MICROCHIP PIC18F2410/2510/4410/4510

PIC18F2410/2510/4410/4510 Rev. B4 Silicon Errata

FIGURE 1: SCK PULSE VARIATION USING TIMER2/2

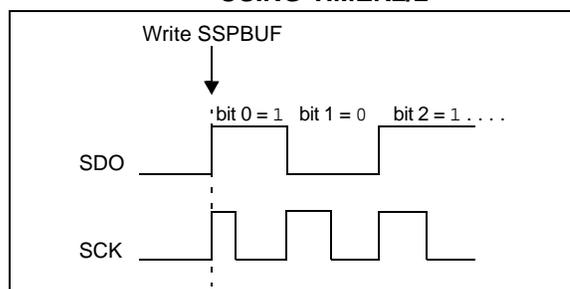
When the SPI is using Timer2/2 as the clock source, a shorter than expected SCK pulse may occur on the first bit of the transmitted/received data (Figure 1).

To avoid producing the short pulse, turn off Timer2 and clear the TMR2 register, load the SSPBUF with the data to transmit and then turn Timer2 back on. Refer to Example 1 for sample code.
